## PLANNING COMMISSION

Monday, September 22, 2014

a. Consider a Site and Design Review & Conditional Use Permit from Verizon Wireless to construct a 100' Monopole with 12 – 8' panel antennas with the tip of antennas at a height of 104', ground equipment installed on a 22' x 3.5' concrete pad, with a 30kW backup generator installed on a 10' x 5' concrete pad, all within a 50' x 50' lease area surrounded by a secure chain link fence with screen slats topped with barbed wire at this unmanned site. **(DR 14-02/CUP 14-01)**

Prepared for the September 22, 2014 Planning Commission Meeting

**Exhibit 1 – Area of Cell Capacity issue. (POR BARLOW)**

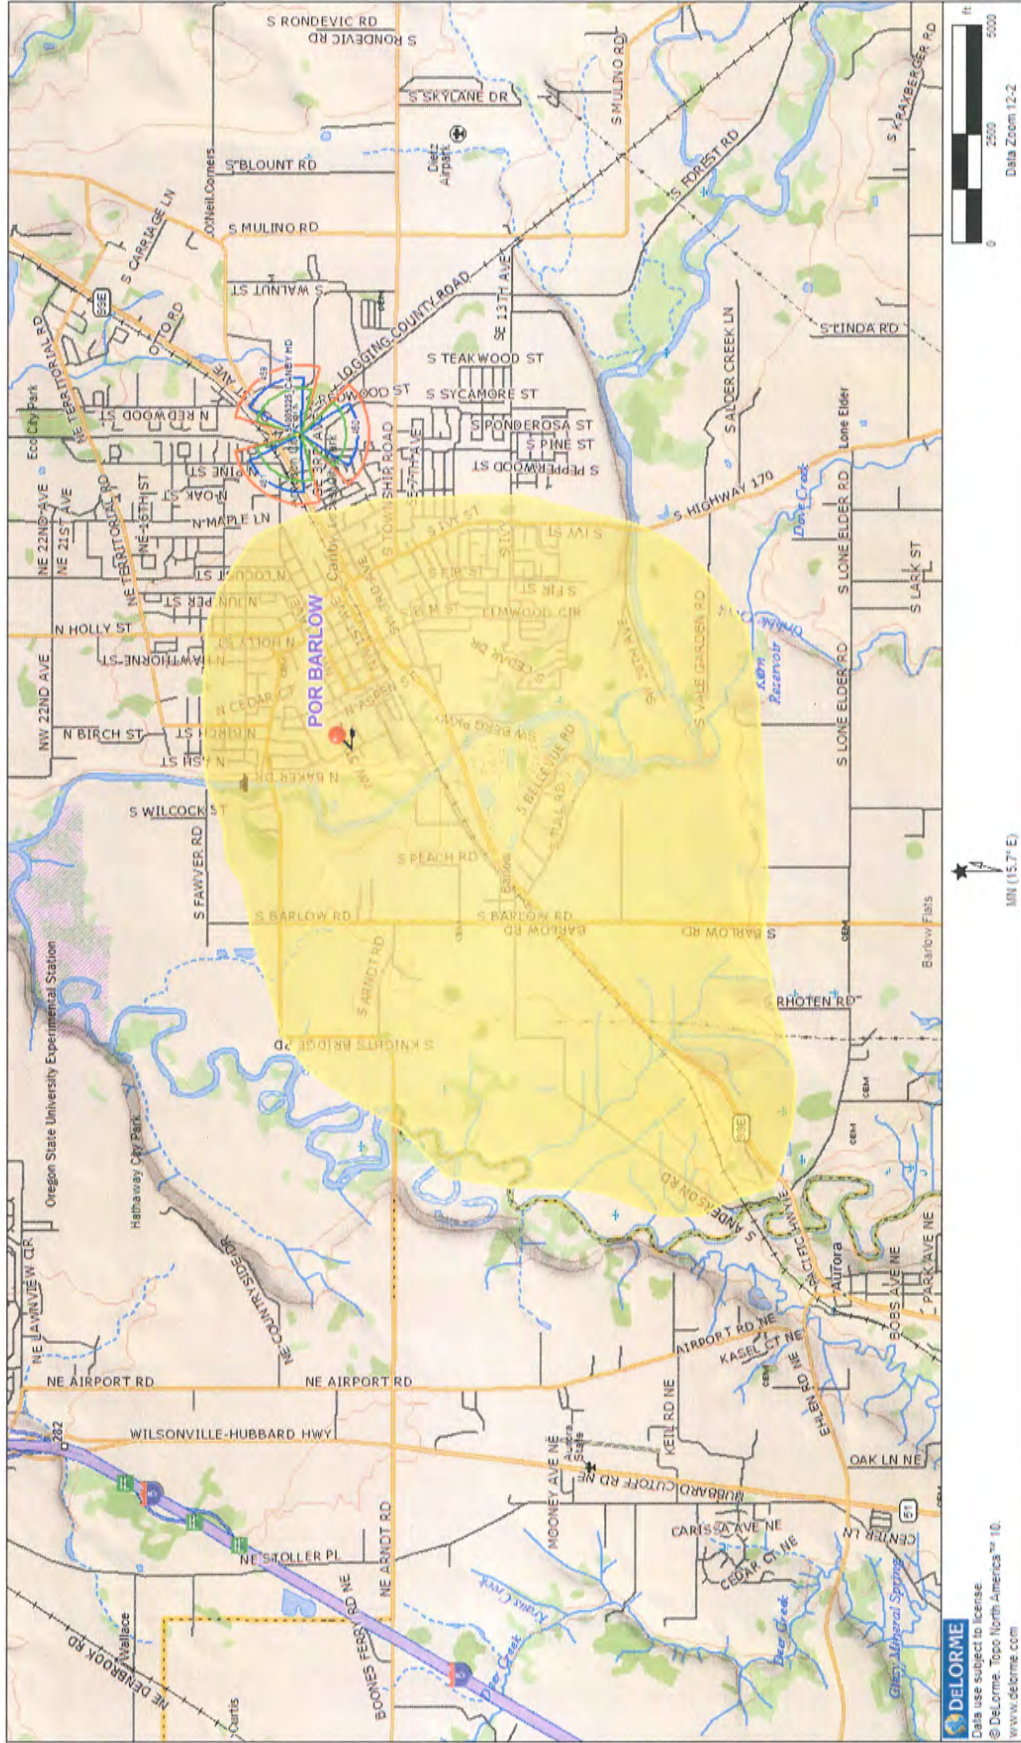
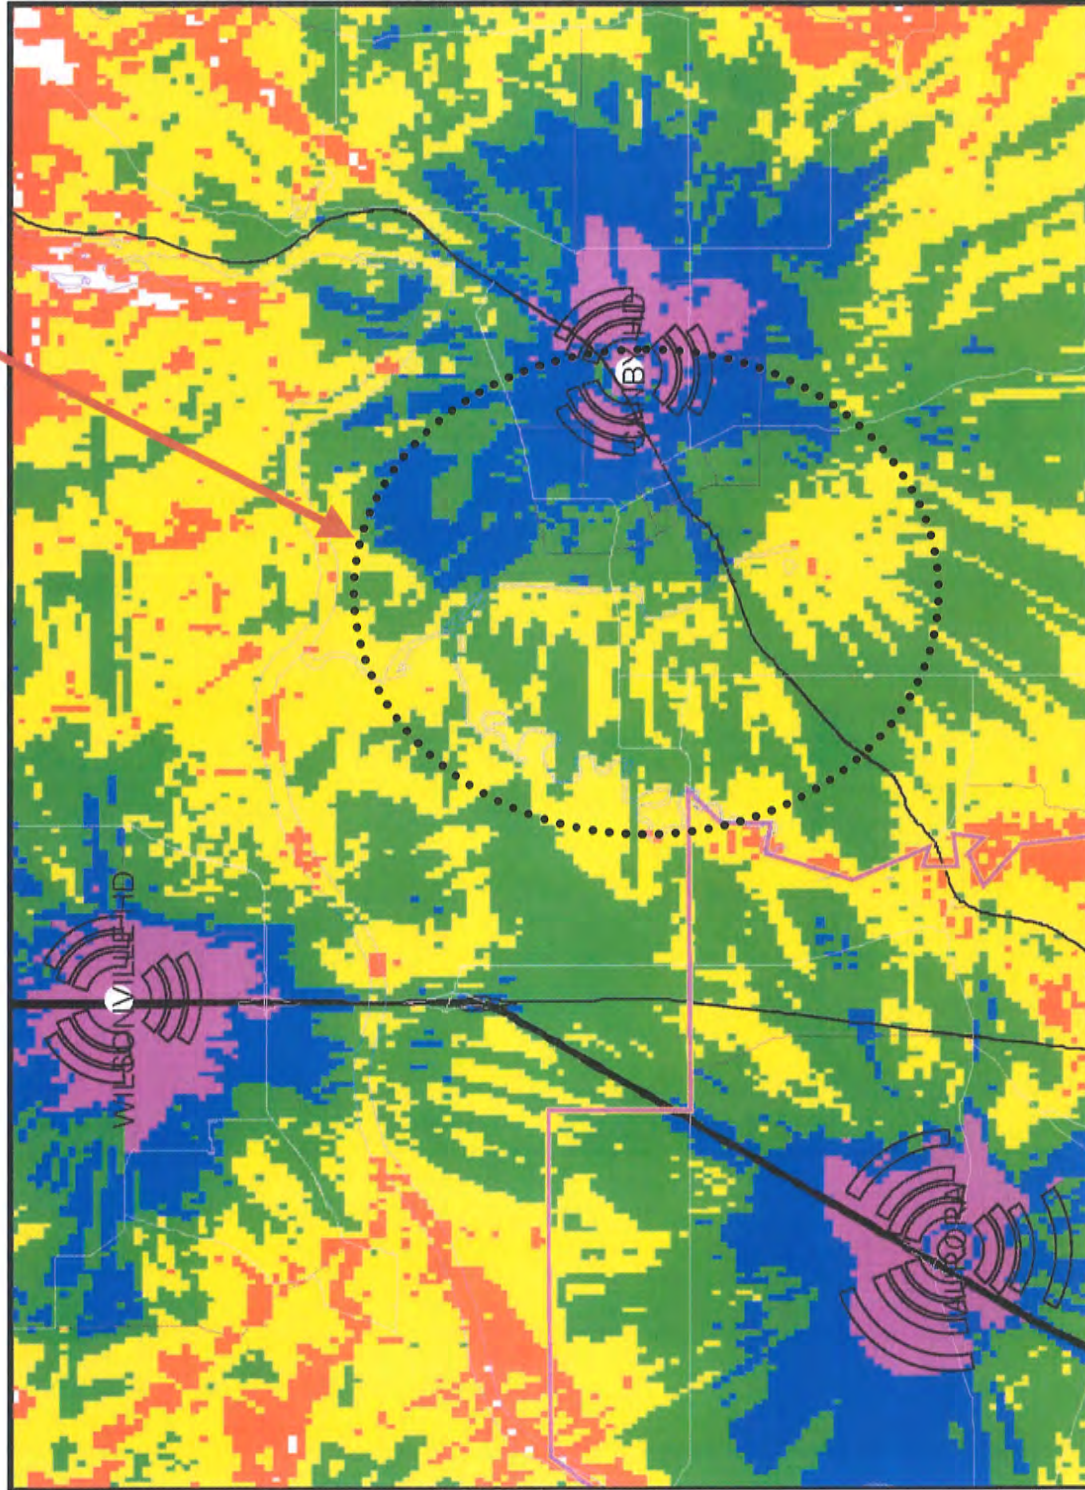
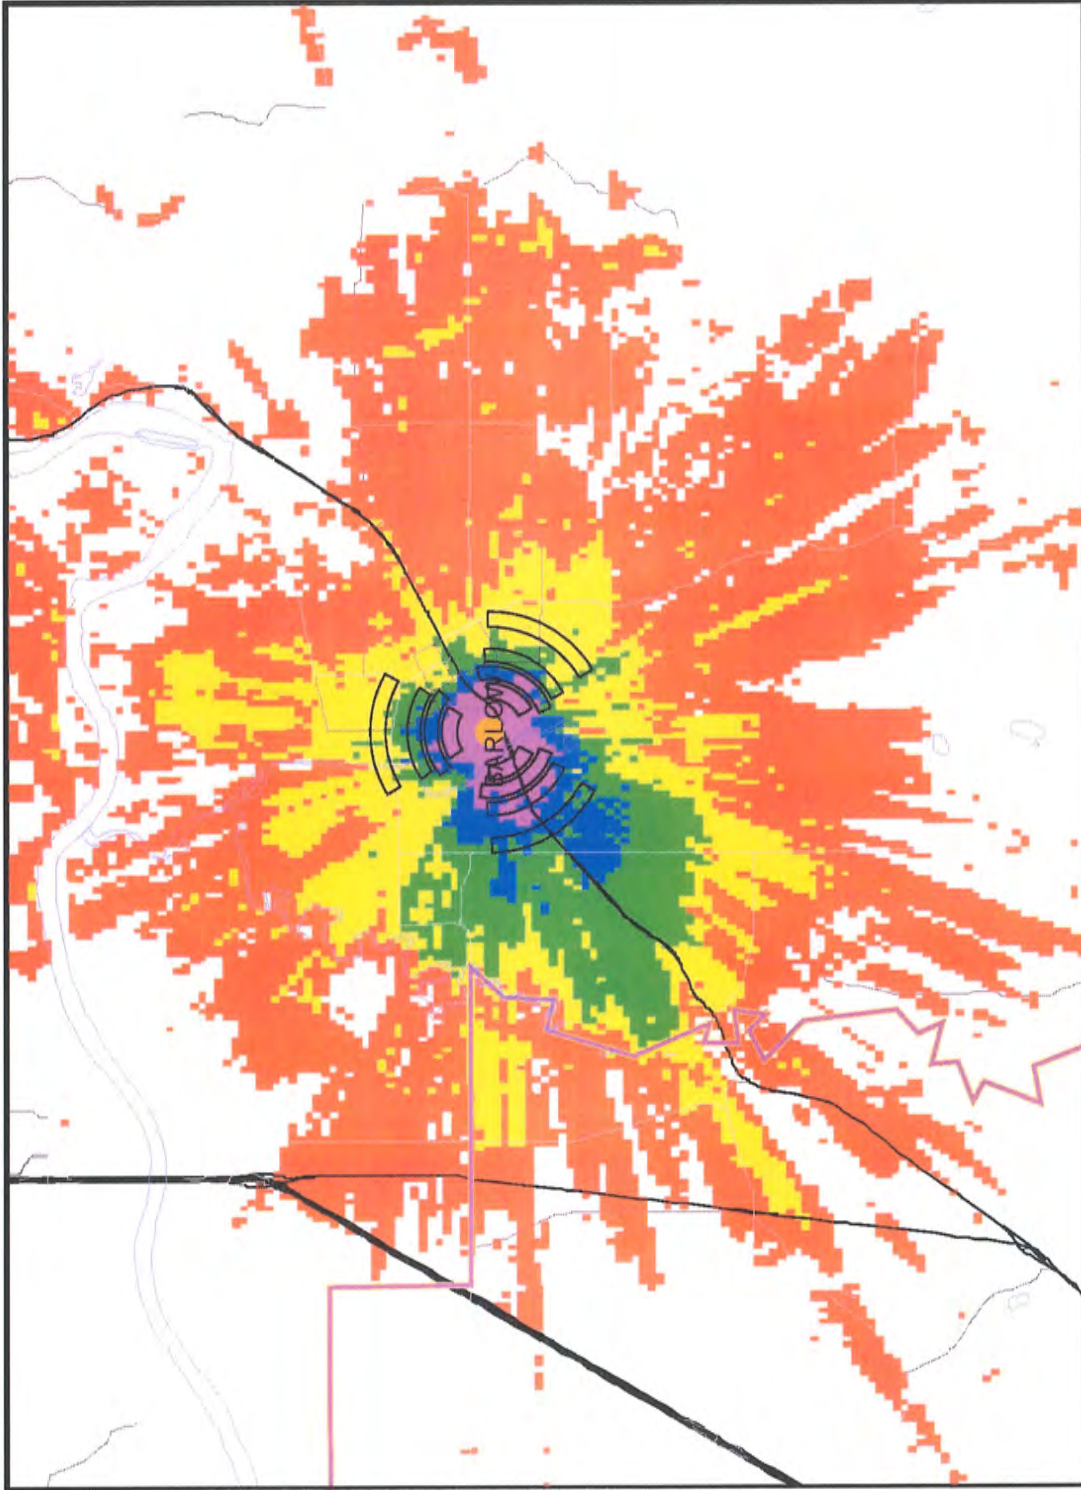
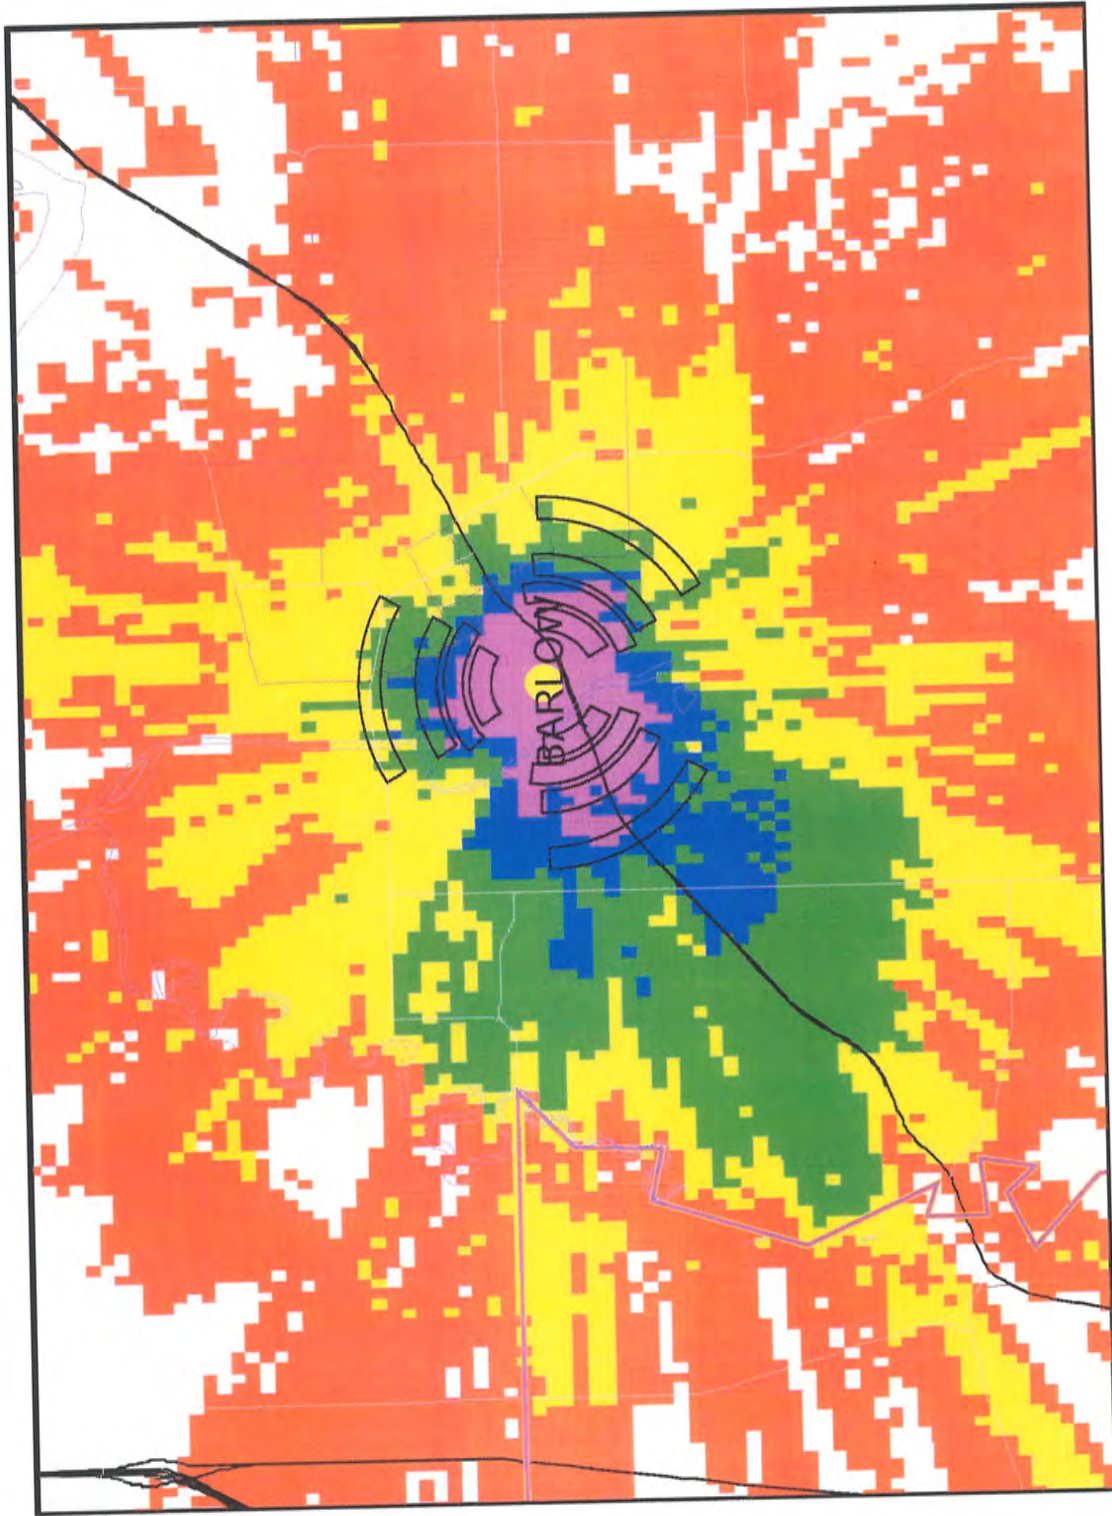
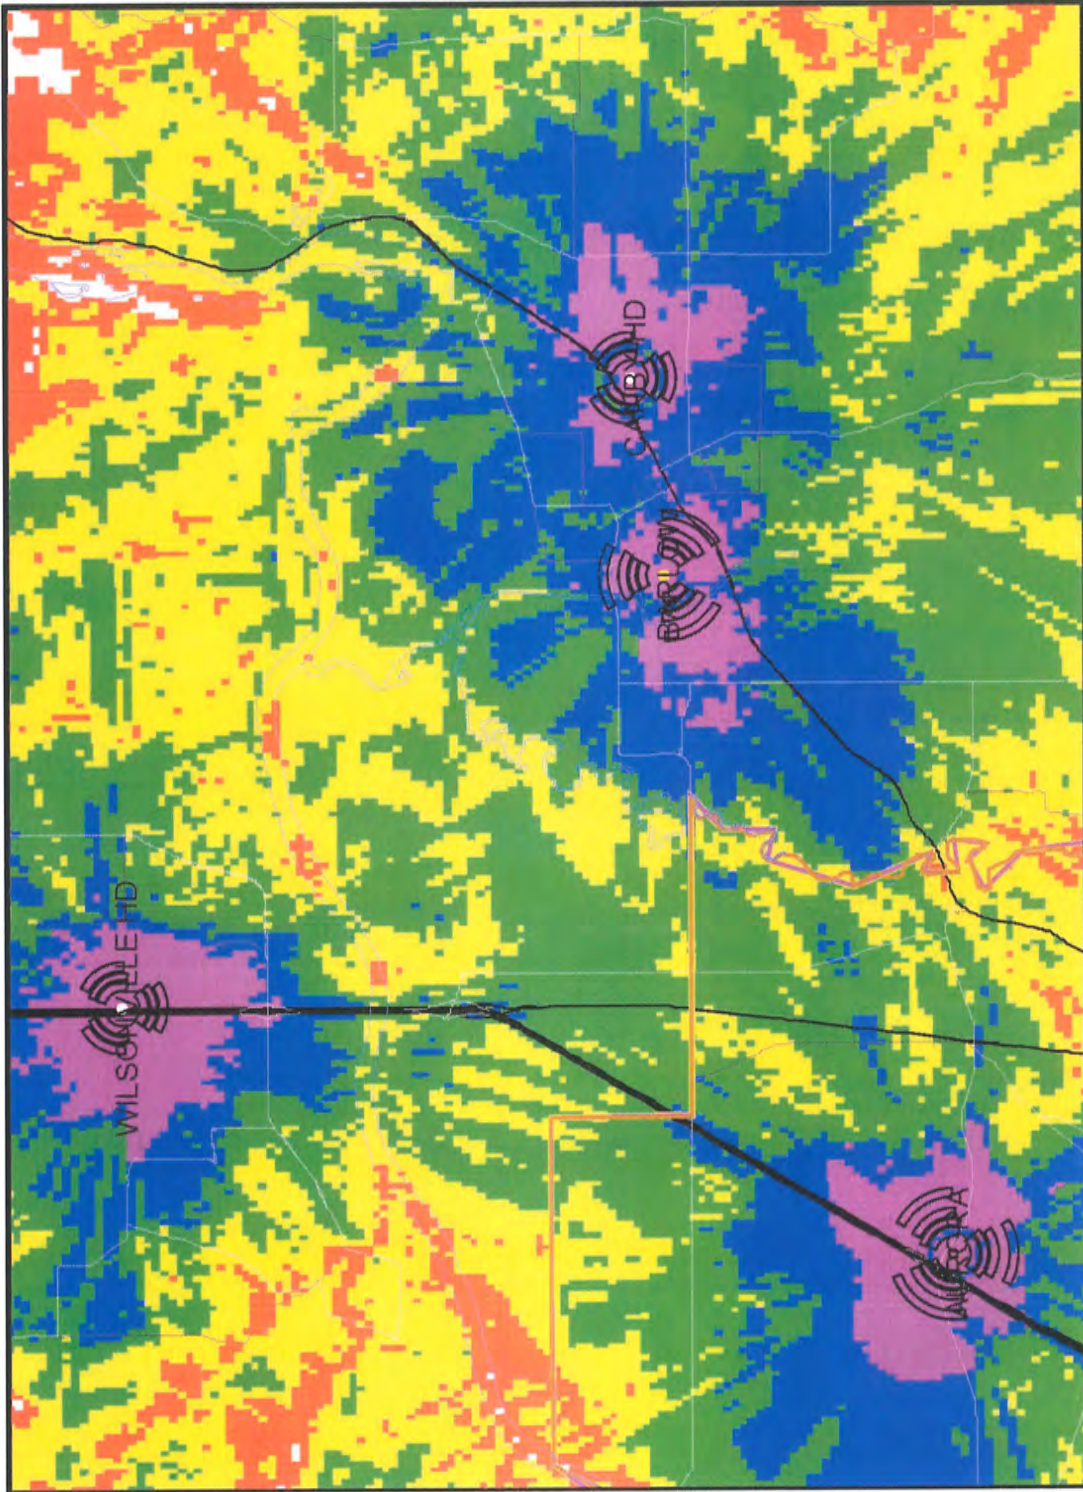
**Findings:** Exhibit G, "RF Engineer's Letter of Explanation" why the proposed facility needs to be located in the general area. Other sites were explored. A willing property owner is needed. The city encouraged consideration of locating on the police building site and evaluation took place. The company chose this site. The applicant states they need a 100' cell tower to meet their coverage goals. It is understood that if the tower were lower at this location, the sought after "coverage" goal would be somewhat less.

Exhibit 3&4 shows coverage/ RF signal emitting of our propose *POR Barlow* site. With our antenna at 100' centerline (C/L), nearly the entire coverage area will be covered by high to moderate RF signal strength, as depicted by the purple, blue, green, and yellow portions of the map. Therefore Exhibit 3&4 meets our design objective for this site; hence the area of coverage is nearly identical to the coverage objective depicted in Exhibit 1. The proposed site in Exhibit 3&4 will provide the additional capacity from propose *POR Barlow* for west of Canby city limit, Highway 99E, Highway 170 and substantial rural area as possible) as depicted in Exhibit 1.

Exhibits 5 & 6 depict how the proposed *POR Barlow* site will be integrated into our network system for that area. Therefore our antenna with a centerline of 100 feet (AGL) will fulfill the capacity objective for *POR Barlow* as depicted in Exhibit 5 & 6. The propose site ensures, RF signal overlaps with adjacent sites to allow continuity of call(s) or "handoff." Therefore a 100' (AGL) antenna centerline is required at the *POR Barlow* site location as shown to provide an uninterrupted service from *POR Wilsonville* site to the north, *SLM Aurora* site to southwest, and *POR Canby* site to the east,. Therefore the *POR Barlow* site will provide the additional capacity for City of Canby and environs.
